SAFETY RECALL BULLETIN

NHTSA RECALL 17V-049

AUTOCAR, LLC SAFETY RECALL ACTT-1701

Autocar has determined that a safety defect exists due to the omission of a dimmer switch for the adjustment of dash illumination on certain 2016-2017 model-year Xspotters.

Figure 2

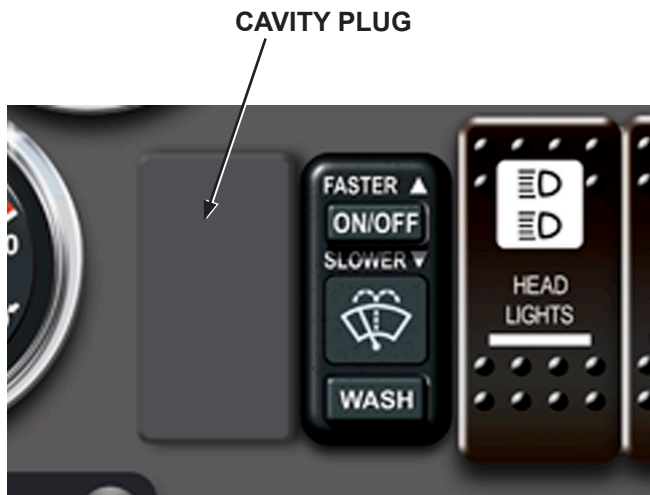
2. Remove the cavity plug and discard (see Figure 2).

Figure 3

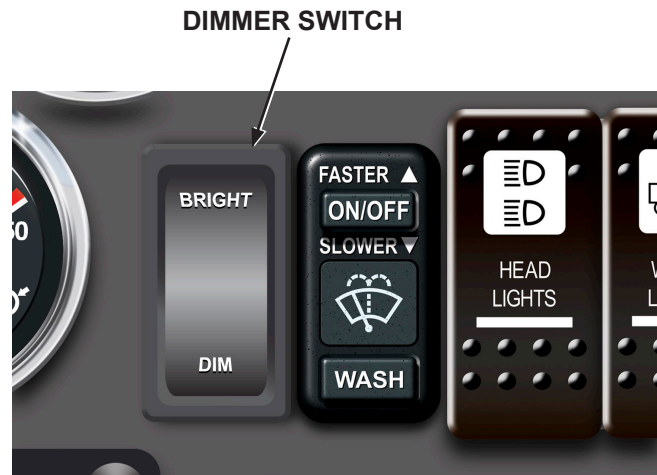
cab harness and insert the dimmer switch into the open cavity until it snaps in place (see Figure 3).

3. From the open cavity, remove the jumper from the cab harness and discard.
4. From the open cavity, connect the new dimmer switch (GZ120004-001) to the
5. Check the dimmer switch for proper functionality.
6. Installation is complete.
